IWUIC

2024 GROUP A PROPOSED CHANGES TO THE I-CODES

WUIC3-24

IWUIC: 403.4

Figure 1. Detached accessory structures condition in 2024 IWUIC Scope.

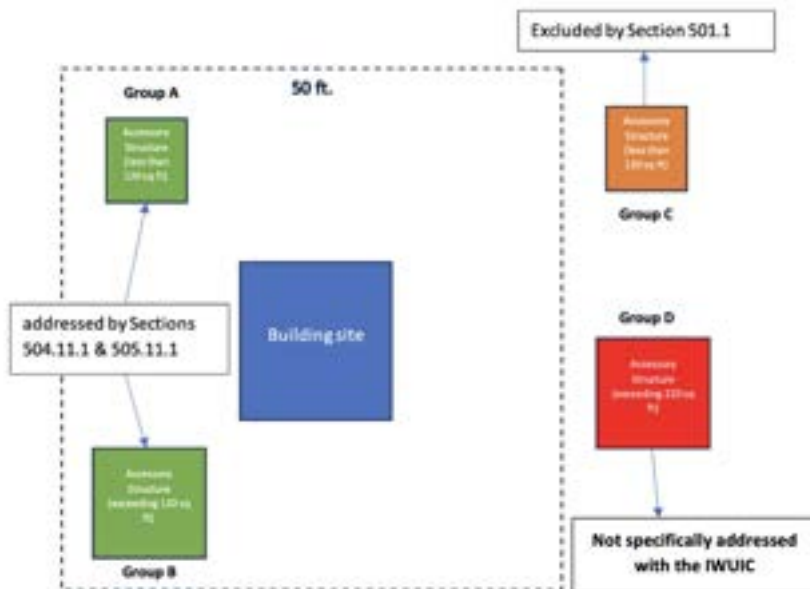
Reason: Based on the current language, detached accessory structures can essentially be categorized into four groups. These groups are illustrated in Figure 1:

- Group A: Detached accessory structures with a floor area of 120 sq ft and less, located less than 50 feet of the primary structure.
- Group B: Detached accessory structures with a floor area greater than 120 sq ft, located less than 50 feet of the primary structure.
- Group C: Detached accessory structures with a floor area of 120 sq ft and less, located 50 feet or more from the primary structure.
- Group D: Detached accessory structures with a floor area greater than 120 sq ft, located at 50 feet or more from the primary structure.

Section 501.1 exempts Group C from the IWUIC, but all other structures must comply with the IBC and the IWUIC. Furthermore, Sections 504.11 and 505.11 of the IWUIC specifically address Group A and Group B detached accessory structures. Sections 504.11 and 505.11 require exterior walls of detached accessory structures located less than 50 feet from a building containing habitable space to be constructed consistent with the required construction of the exterior walls of primary structure. Group D (located 50 feet or more from the primary building and a floor area exceeding 120 square feet) is not specifically addressed by the IWUIC. The lack of specificity could lead

To address this issue, the proposed language recommends exempting all detached accessory structures located more than 50 feet away from a habitable building from the scope of IWUIC. This suggestion is supported by the findings of structure separation experiments conducted by the IBHS and NIST. These experiments indicate that when the separation distance between structures exceeds 50 feet, the risk of conflagration and structure ignition is significantly lower [1-3]. Chapter 7A of the California Building Code also includes similar requirements in Section 710A.3 (Figure 3) and this change will align these two codes from this perspective [4].

Figure 2. a. 1-hour fire resistance rated exterior wall with OSB sheathing panel on the exterior side [1].

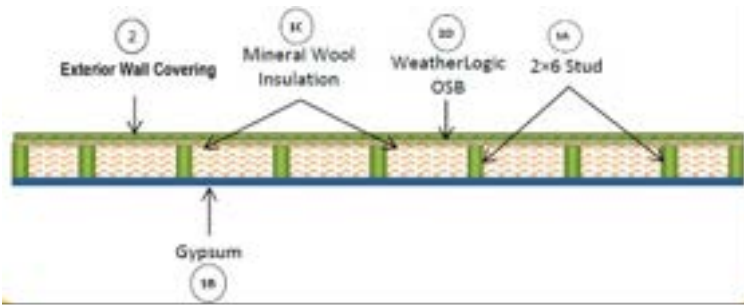
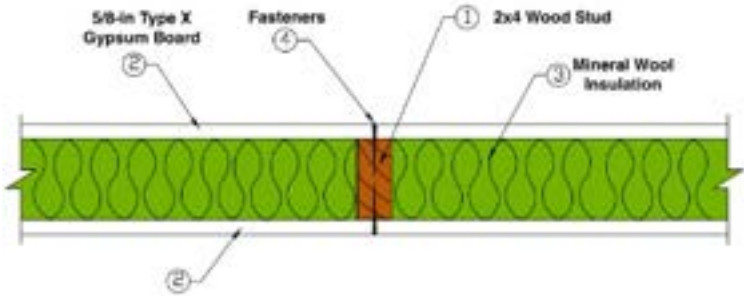
Another concern with 1-hour FRR alone is the wide range of wall assemblies that can meet the performance requirements of ASTM E119. Figure 2 shows two different wall assemblies that achieve 1-hr FRR from either side.

While Figure 2a and 2b both qualify as 1-hr FRR construction, the assembly in Figure 2a is particularly vulnerable to wildfire exposure at the base because combustible sheathing material is used in the assembly. Figure 3 shows a series of fire tests conducted at the IBHS Research Center where different configurations of 1-hour fire-resistant rated assembly with combustible engineered wood siding material were exposed to a small fire at the base. Figure 3a is about a typical 1-hour fire-resistant rated assembly constructed with OSB sheathing material. In this test the OSB sheathing material is exposed from bottom. During this experiment, the fire spread across the surface of the combustible exterior siding and impinged inside the wall cavity because of the exposed bottom surface of OSB sheathing material. Figure 3b shows a 1-hour fire-resistant rated assembly constructed with noncombustible sheathing material in accordance with Figure 2b. In this experiment the fire only ignited the combustible engineered wood siding material and did not impinge inside the wall assembly.

Figure 1. 6-in gap at the ground level (IWUIC Commentary).

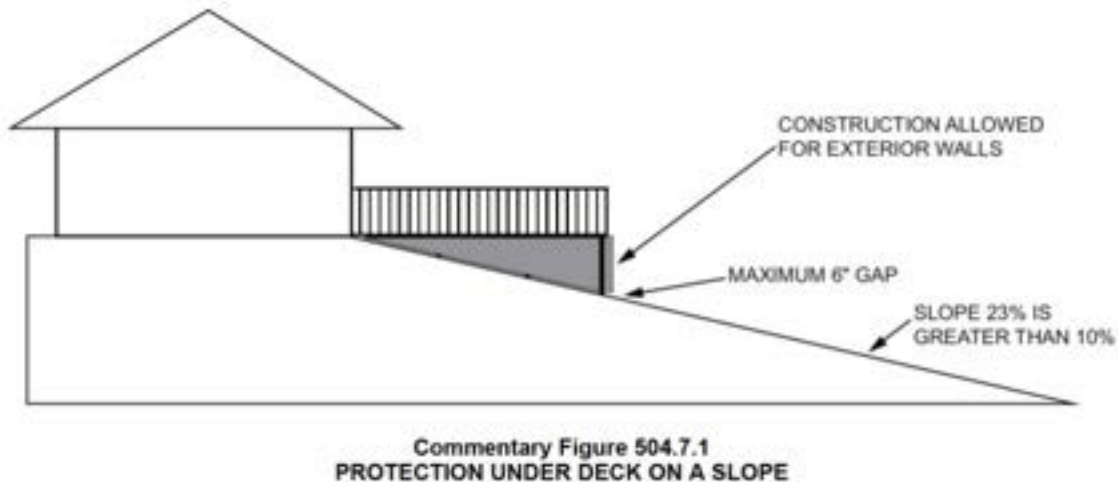
Reason: Figure 1 clarifies the intention of sections 504.7.1 and 505.7.1. There are 4 concerns surrounding the current requirements of the IWUIC regarding the construction of an underfloor area of attached accessory structures.

First, there is no scientific reason to support the slope limitations provided in these sections. All structures, their attached accessory structures, detached accessory structures and their underfloor areas are exposed to at least one of the wildfire exposures. As it is well studied, wildfires can threaten buildings through three different exposures: embers, radiation heat, and direct flame contact. Excluding the underfloor area of attached accessory structures located on a surface with a slope less than 10 percent will result in excluding many balconies, decks, stairs, and other attached accessory structures constructed on flat surfaces. The code requirements should not

differentiate between underfloor areas of building and attached structures. This is also against the requirements provided in the California Building Code (Chapter 7A, Section 707.9A).

Second, technical concerns around having a 6-in opening at the base of walls. Currently, the code requires the underfloor areas of attached accessory structures to be fully enclosed to within 6 inches (152 mm) of the ground (Figure 1). The 6-in opening seems to be required for water irrigation purposes. However, this requirement does not align well with provided construction methods for attached accessory structures.

FIGURE 603.2 MEASUREMENTS OF FUEL MODIFICATION DISTANCE

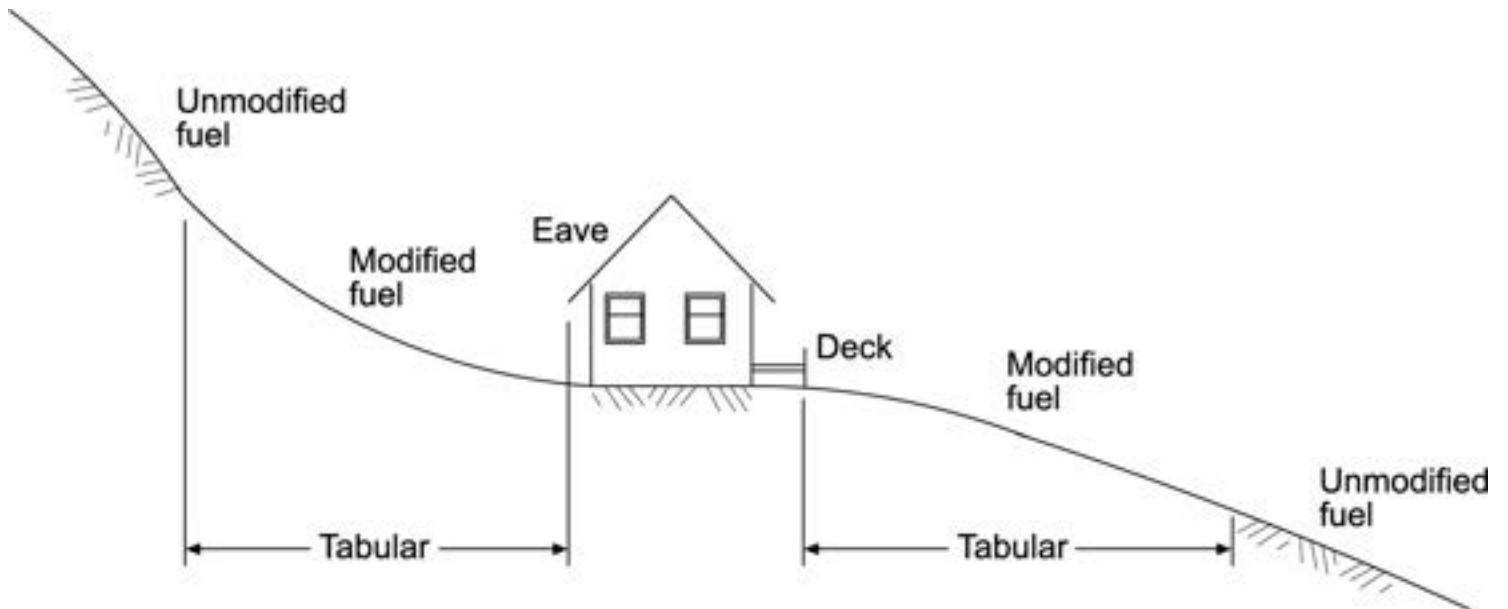
603.2 Fuel modification. Buildings or structures, constructed in compliance with the conforming *defensible space* category of Table 503.1, shall comply with the *fuel modification* distances contained in Table 603.2. For all other purposes the *fuel modification* distance shall be not less than 30 feet (9144 mm) or to the lot line, whichever is less. Distances specified in Table 603.2 shall be measured on a horizontal plane from the perimeter or projection of the building or structure as shown in Figure 603.2. Distances specified in Table 603.2 are allowed to be increased by the *code official* because of a site specific analysis based on local conditions and the *fire protection plan*.

FIGURE 603.2 MEASUREMENTS OF FUEL MODIFICATION DISTANCE

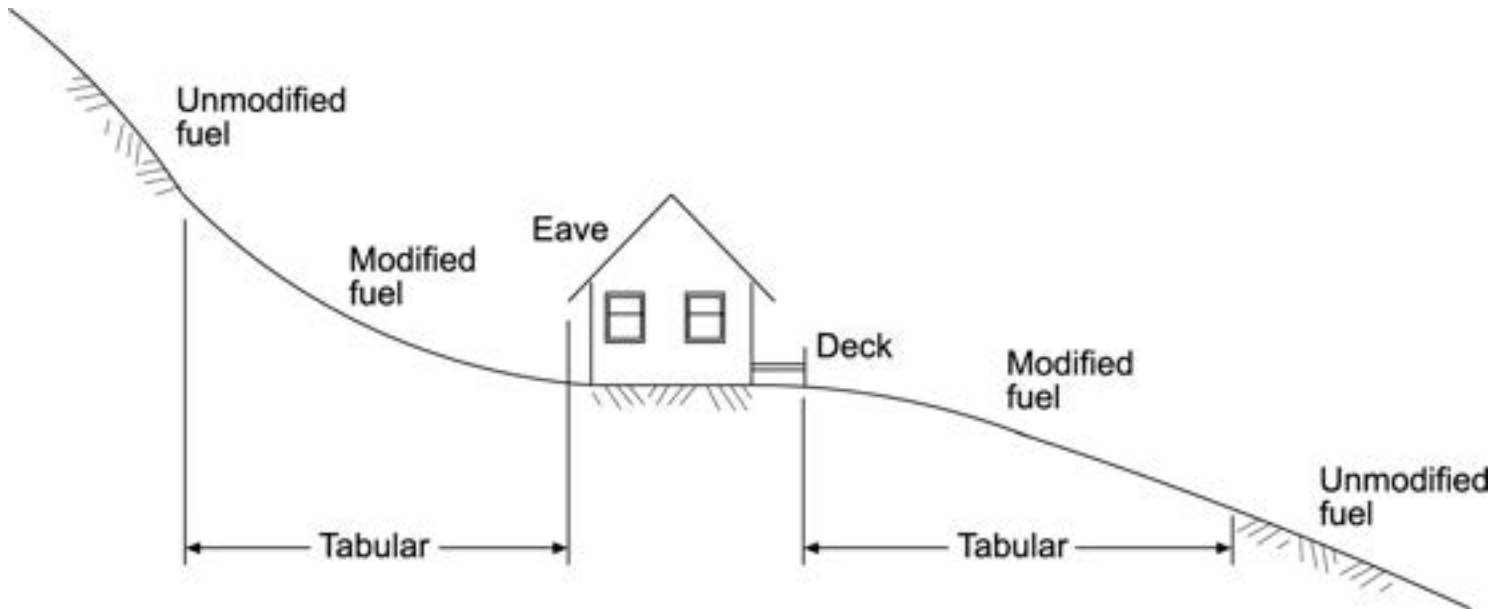
603.2 Fuel modification. Buildings or structures, constructed in compliance with the conforming *defensible space* category of Table 503.1, shall comply with the *fuel modification* distances contained in Table 603.2. For all other purposes the *fuel modification* distance shall be not less than 30 feet (9144 mm) or to the lot line, whichever is less. Distances specified in Table 603.2 shall be measured on a horizontal plane from the perimeter or projection of the building or structure as shown in Figure 603.2. Distances specified in Table 603.2 are allowed to be increased by the *code official* because of a site-specific analysis based on local conditions and the *fire protection plan*.
